**From:** Joe Minor  
**Sent:** June 30, 2011 4:03 PM  
**To:** clerk@hamilton.ca  
**Subject:** PFOS (again, this is "new", really....)

**Re: Hamilton International Airport – Hamilton, ON  
PFC Sampling and Mitigation**

FIRE TRAINING STATION EX. CONDITIONS	
SCALE:	Fig. 1
N.T.S.

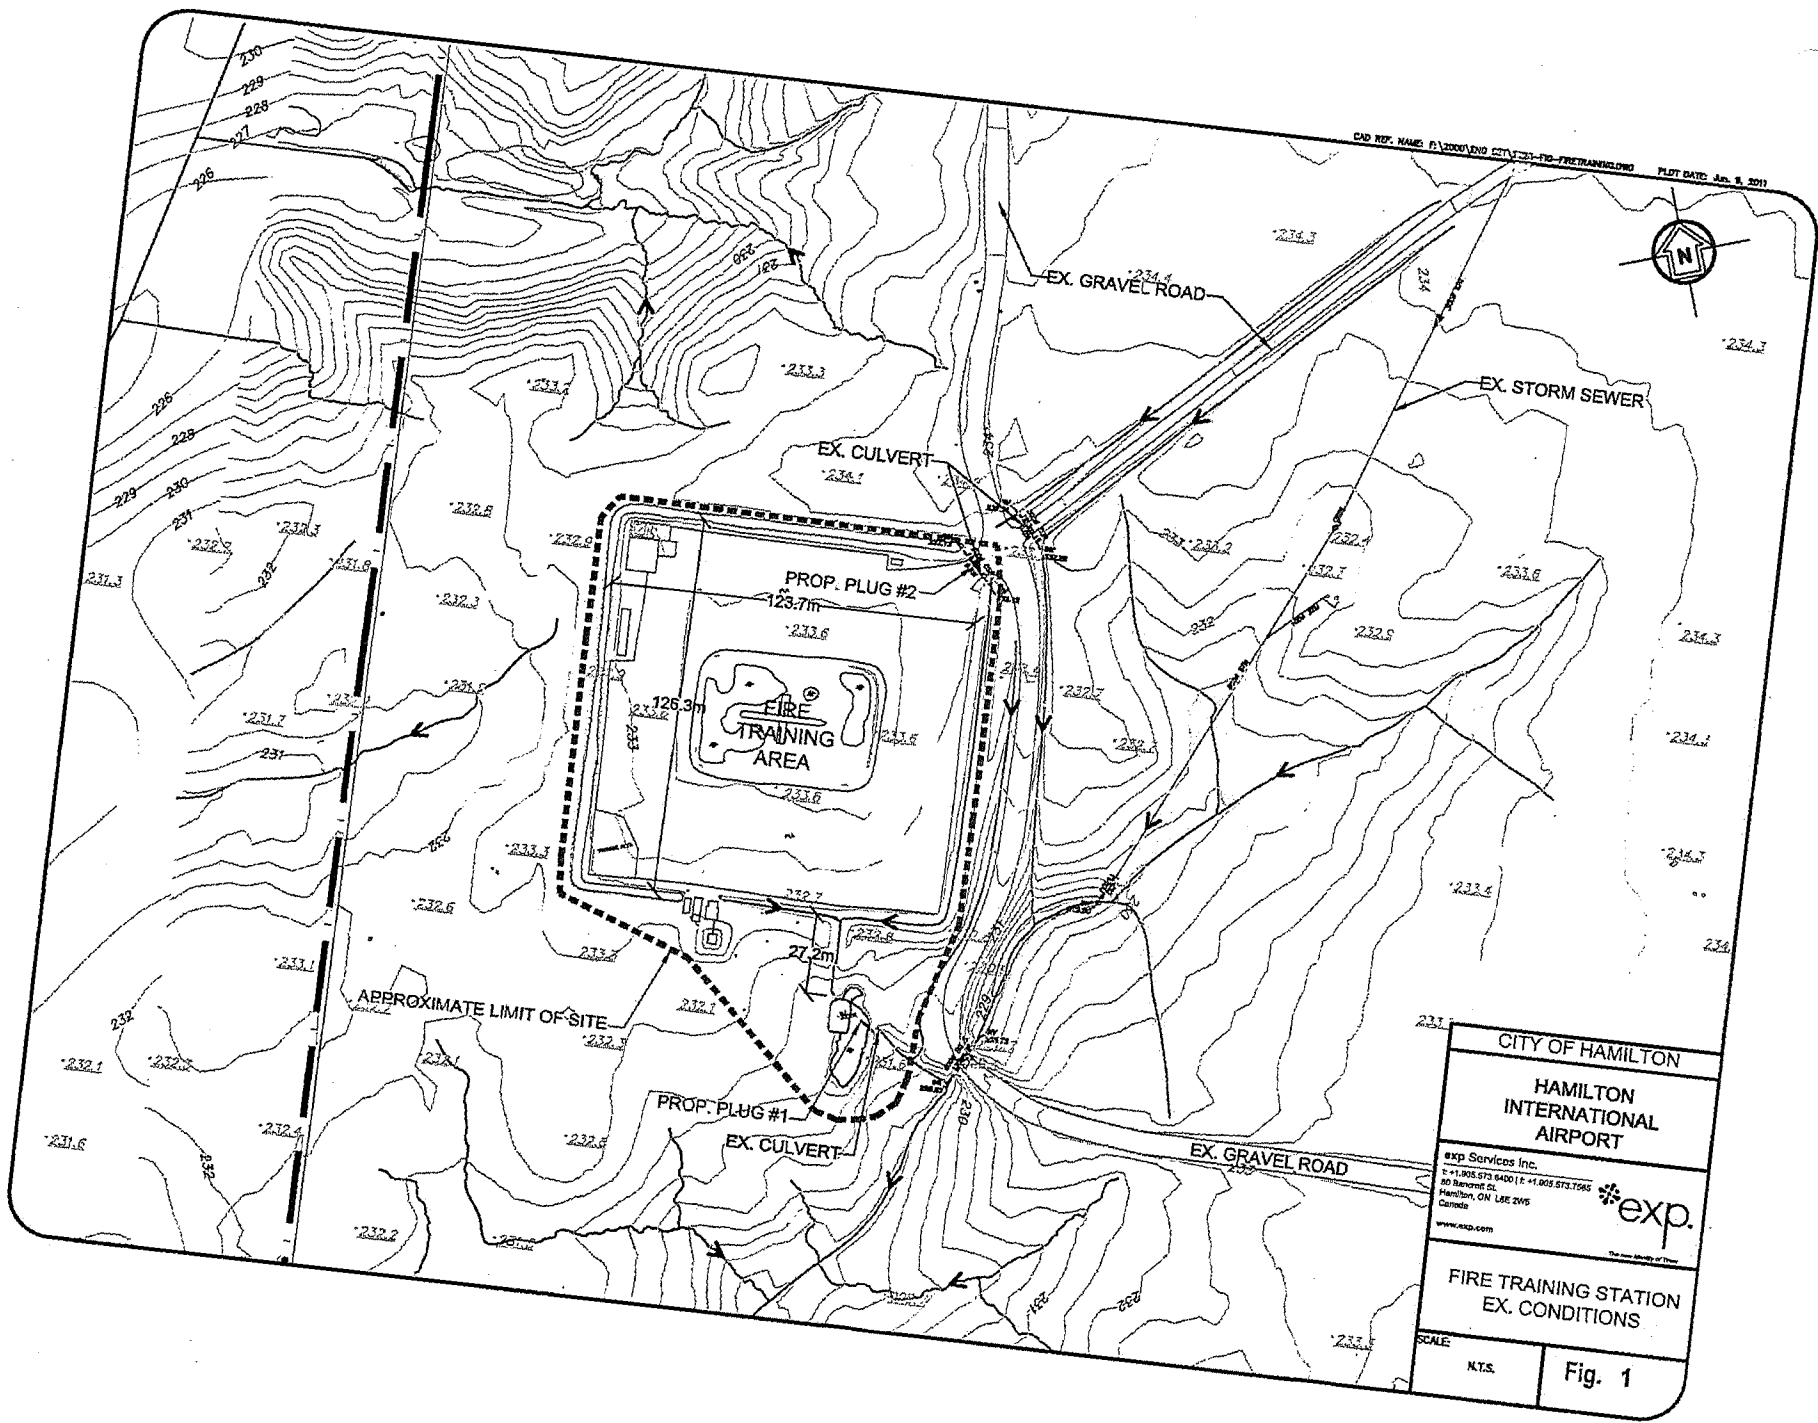
"Prop. Plug #2" is a good idea, and should be installed immediately. In addition, efforts to plug excavations and to keep precipitation from falling on the pad and mobilizing PFOS out of the pad (mostly to surface water, but also potentially to groundwater) need to be implemented as soon as possible (see June 22nd note below).

"Prop. Plug #1" is actually an interesting science experiment. By impounding PFOS contaminated water in the pond and on the pad, the science question that is being asked is: "If we try really hard, can we drive PFOS into groundwater?" I do not think this is a responsible science experiment to be running, for two reasons. First, it is not a clean science experiment, because the issue of PFOS contamination under the pond and pad before the start of the experiment has not been examined. Second, I think the liability costs if groundwater contamination is increased by this experiment could be enormous. The problem with impounding highly contaminated water on the ground is that the stored contaminated water will "search" for any openings to escape to groundwater.

The "exp" engineer's report states: "Due to summer conditions, overflows from the ditch or pond are not expected to occur." Due to the total lack of supporting data, this is an irresponsible statement to be coming from a professional engineer. First, the retention pond is much smaller in size than the pad itself, and its storage capacity relative to its "watershed" would appear to be quite limited. (There is no evaluation of either storage capacity or storage needs in the engineer's report. There is actually more data on this issue in my last letter to Council than there is in the engineer's report.) Second, there is no evaluation of current weather conditions for this area. In recent years, there have been (according to the City's engineers) multiple "100 year" rain events that have occurred in the summer. Two occurred in the summer of 2009 alone, resulting in serious summer "overflows" that flooded the Red Hill Creek Expressway.

I would like to know what the drainage area and average annual discharge are for the "ex. storm sewer" shown in Fig.1 of the "exp" report. If these numbers are large, then my estimates for the amount of PFOS that the airport "contributes" annually to the Welland River will need a substantial upward revision.
